### **Amendments to the Drawings**

### **REMARKS**

FIG. 1a

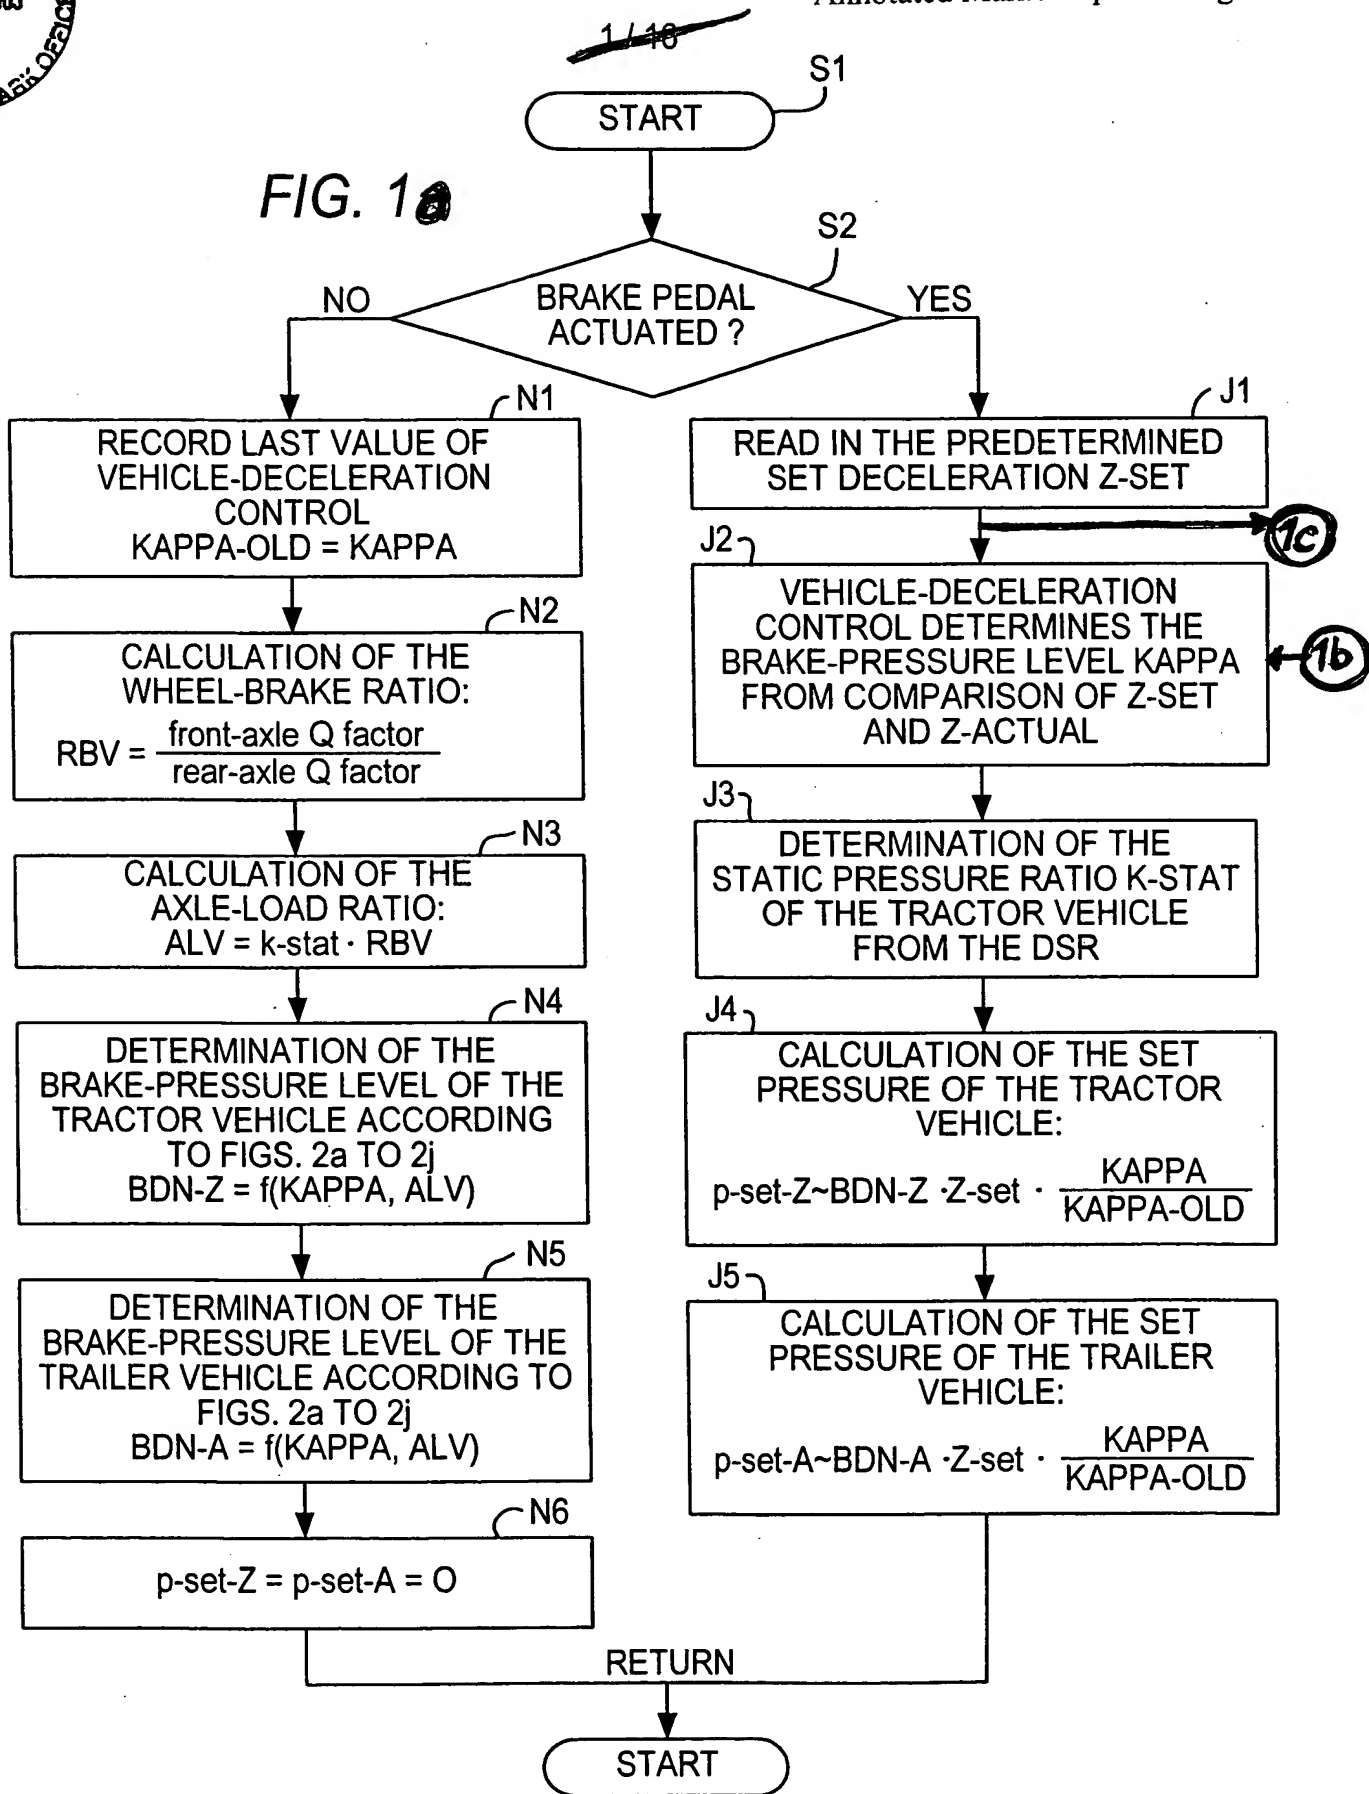
Regarding the vehicle dynamics data, as depicted in the attached Replacement Sheets and Annotated Marked-Up Drawing Sheets, Applicants have added Fig. 1b which shows such data as well as vehicle combination mass as possible inputs to step J2 of Fig. 1. Applicants have also added Fig. 1c which shows a step J1a of filtering the brake-application energy reference value. Fig. 1 has been relabeled "Fig. 1a" to accommodate the addition of Fig. 1b as well as Fig. 1c.

Applicants do not understand, and accordingly respectfully request that the Examiner clarify, the objection to the relationship depicted in block J5 of Fig. 1. As set forth in the application specification as filed (see paragraph [0035] of the published application, for example), this equation describes how the set brake-application energy value P-set-A can be calculated from the mathematical relationship  $BDN-A \cdot Z_{set} \cdot (\kappa/\kappa_{old})$ . Applicants respectfully submit that the equation speaks for itself.

FIG. 2b

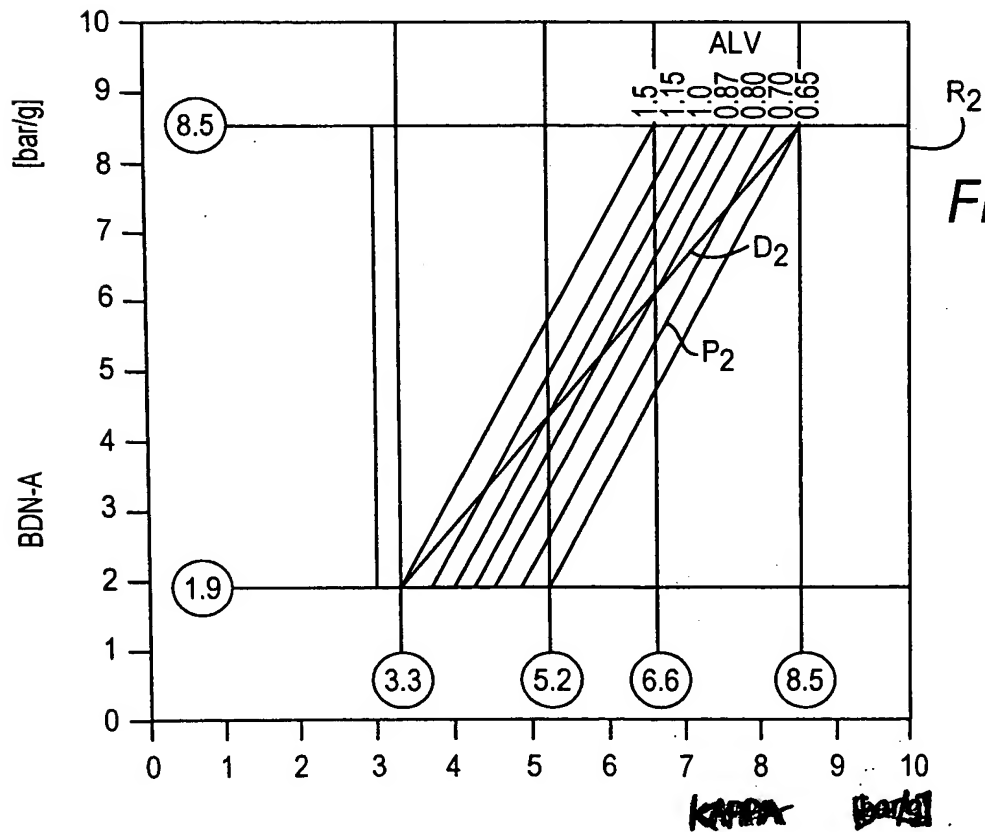
The Examiner further objected to the drawings because the x-axes of the graphs depicted in Figs. 2b, 2d, 2f, 2h and 2j are not separately labeled. As depicted in the attached Replacement Sheets and Annotated Marked-Up Drawing Sheets, Applicants have added the label “KAPPA [bar/g]” to each of these graphs.

The label “KAPPA [bar/g]” has been added to the x-axes of the graphs depicted in Figs. 2b, 2d, 2f, 2h and 2j. Elements Z, AA-1, AA-2 and AA have been deleted from Fig. 3a. Original Fig. 1 has been relabeled “Fig. 1a” and references to new Figs. 1b and 1c have been added to accommodate new Figs. 1b and 1c. New Fig. 1b shows data inputs to step J2 of Fig. 1a; new Fig. 1c shows a step J1a of filtering the brake-application energy reference value. New Fig. 9 is a simplified schematic diagram of a tractor vehicle (and partial view of a trailer vehicle) of a conventional tractor-trailer vehicle combination showing an EBS and including an EBS control unit 10 (which includes the capability of effecting filtering of the brake application energy reference value) and means for determining actual deceleration 20, a brake pedal 30, including a signal transmitter for desired brake values 40, brake actuators 50, 60 for the front and rear axles, respectively, wheel speed sensors 70, 80 and axle load sensors 90, 100.

FIG. 9

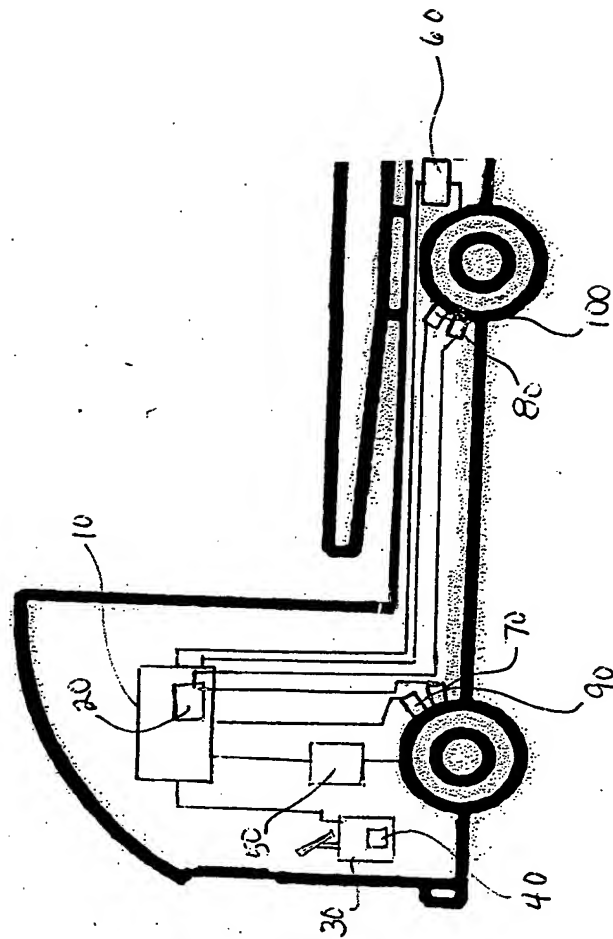
In the Office Action, the Examiner first objected to the drawings as not showing (i) the axle load sensors (or the means for determining axle load) as recited in claim 17, (ii) the vehicle dynamics data (including engine power and transmission ratio) as recited in claim 23, (iii) the means for enabling the filtering of the brake application energy reference value as recited in claim 24, (iv) the means for measuring actual deceleration as recited in claim 28, (v) the electronic braking system recited in claim 1, and (vi) the elements recited in claim 5. The

To address the Examiner's concerns and promote the application to early allowance, as depicted in the attached Replacement Sheets and Annotated Marked-Up Drawing Sheets, Applicants have added new Fig. 9 to the drawings which is a simplified schematic diagram of a tractor vehicle (and partial view of a trailer vehicle) of a conventional tractor-trailer vehicle combination showing an EBS and including an EBS control unit 10 (which includes the capability of effecting filtering of the brake application energy reference value) and means for determining actual deceleration 20, a brake pedal 30, including a signal transmitter for desired brake values 40, brake actuators 50, 60 for the front and rear axles, respectively, wheel speed sensors 70, 80 and axle load sensors 90, 100. As these elements are conventional, they are shown as "black box" labeled representations.
